SEWAGE DISPOSAL SYSTEM

SUBDIVISION Spring Valley Chase LOT 34 ROAD 12180 Woodford Drive

Re: Building Permit #61930
Spring Valley Chase, lot 34
12180 Woodford Drive
Marriottsville, MD 21104

SITE PLAN

SPRING VALLEY
CHASE
LOT 34

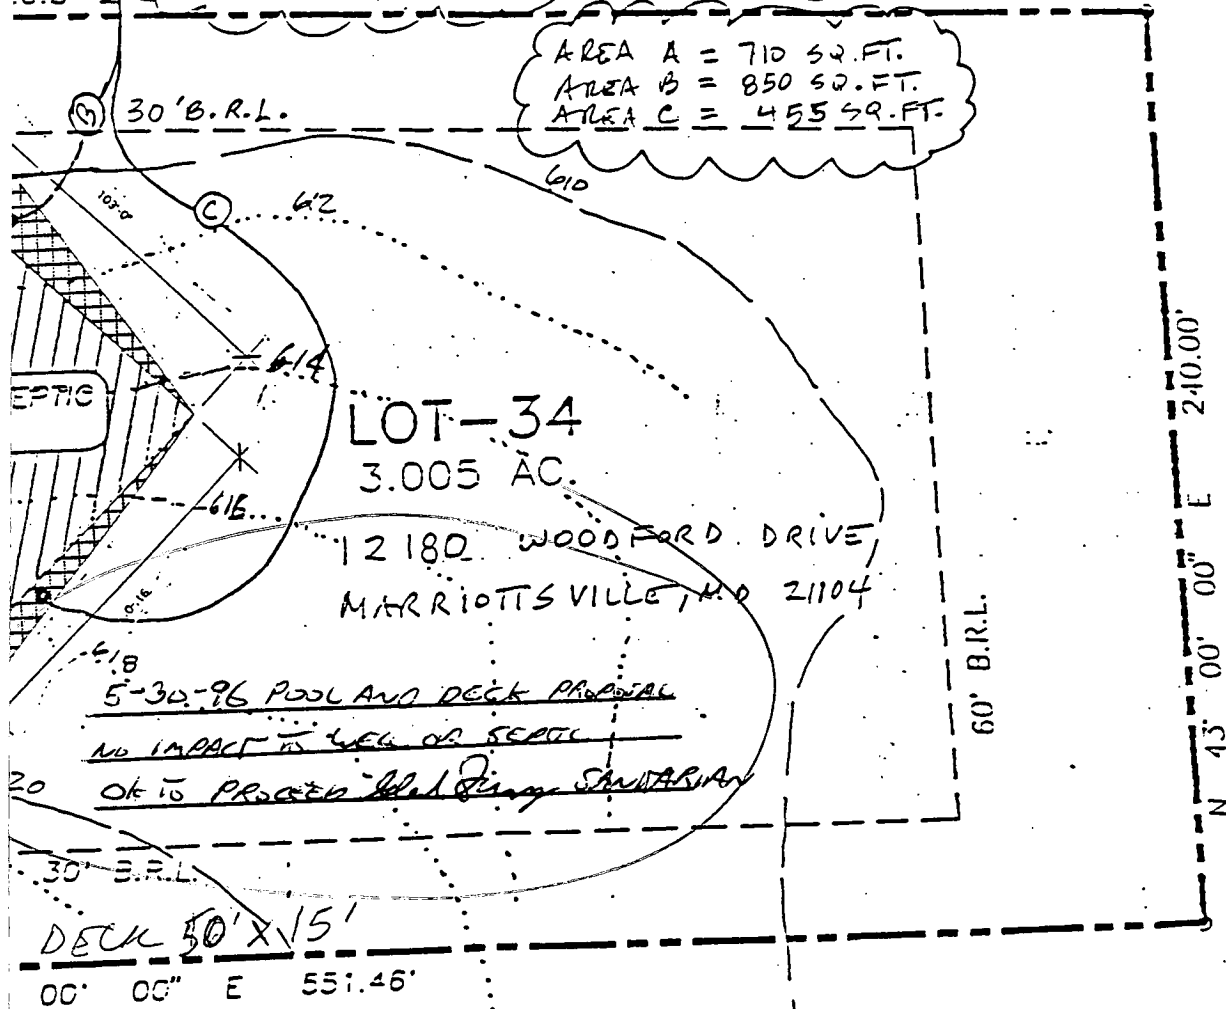
* ADD THESE AREAS
TOTALING 2015 ± SQ.FT.

AREA A = 710 SQ.FT.
AREA B = 850 SQ.FT.
AREA C = 455 SQ.FT.

REMOVE THIS AREA
(1500 SQ.FT. ±)

Our client would like to add a screened porch to the rear of her above referenced home currently being constructed. The location of the proposed screened porch would be fewer than 20' away from the designated septic area. We are proposing a revision of the septic area to allow room for the screened porch and a future pool.

Our proposed revision, as shown on the enclosed drawing, would remove approximately 15' x 100' (1500 sq. ft.) of the west side of the septic field and replace that area with three triangular areas (totaling 2015 sq. ft.) on the north, south and east sides of the septic field. Please review our proposal to determine if it is acceptable. If you need any additional information, or have any questions, please page me at 410-475-8310. Thank you in advance for your assistance

BY COPY OF THIS PLAN THE
HEALTH DEPT. ACCEPTS
THE PROPOSED MODIFICATIONS
TO THE SEWAGE EASEMENT

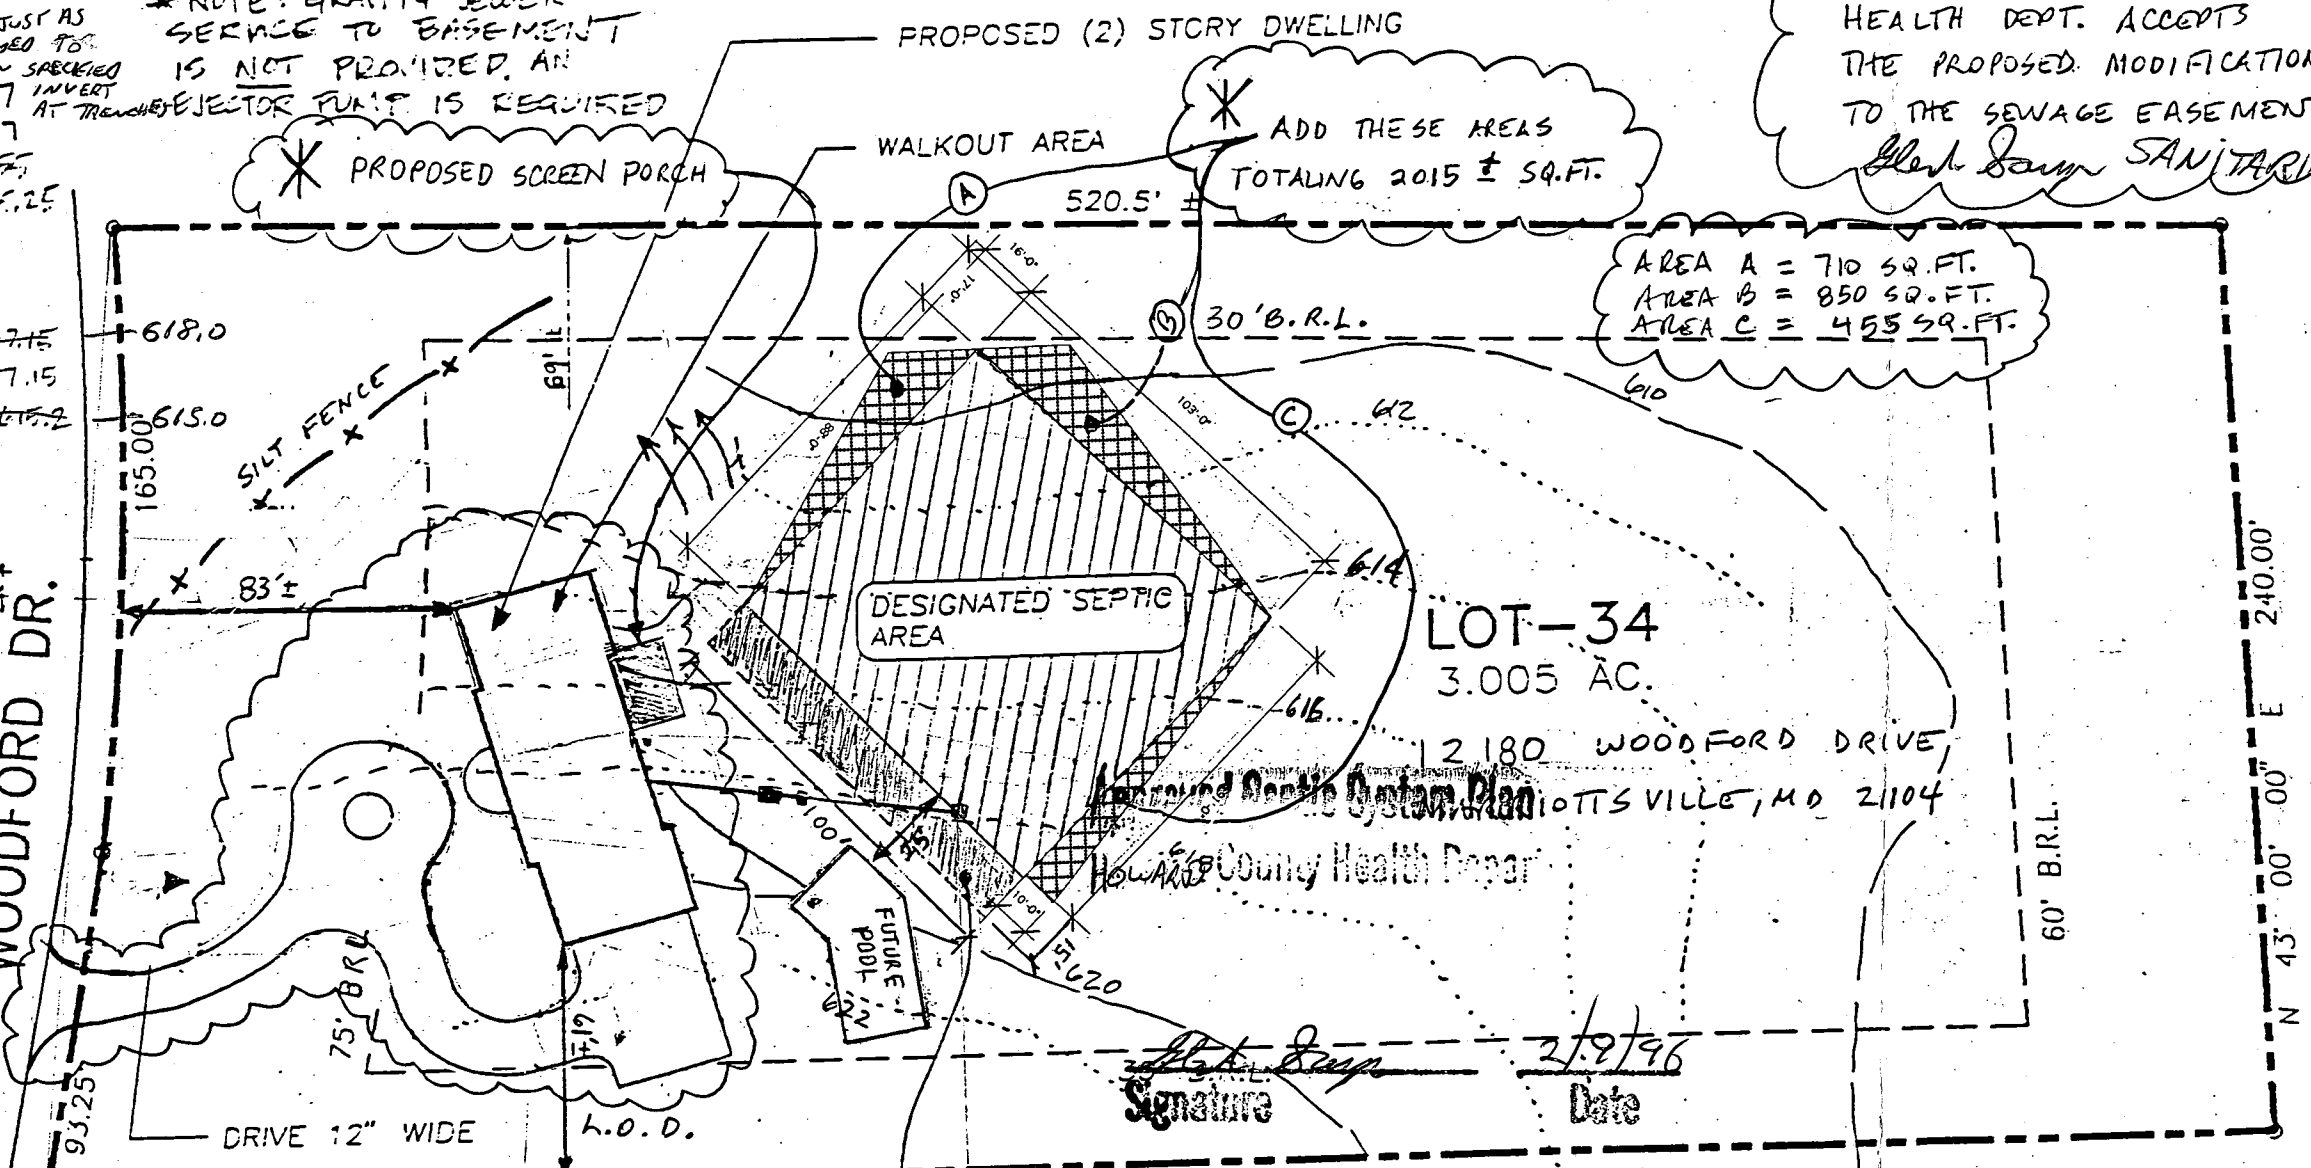
TANK ADJUST AS NEEDED TO MAINTAIN SPECIFIED INVERT AT TRENCH EJECTOR PUMP IS REQUIRED
EX. GR. 617.7
FIN. GR. 617.7
INV. IN 615.55
INV. OUT 615.25

* NOTE: GRAVITY SEWER SERVICE TO BASEMENT IS NOT PROVIDED. AN EJECTOR PUMP IS REQUIRED

NOTE: ADJUST HOUSE & SEPTIC TANK INVERTS TO ACCOMMODATE SEPTIC EASEMENT CHANGES

LENGTH OF TRENCHES TO BE DETERMINED

* REMOVE THIS AREA (1500 SQ. FT. ±)

2-9-96 PROPOSED PORCH & POOL
ADDITIONS APPROVED - SUPPORTED BY SDA REVISION
Alfred Sam SANITARIAN
SPRING VALLEY CHASE
LOT 34

2-9-96 SDA REVISED
DO NOT USE THIS PLAN
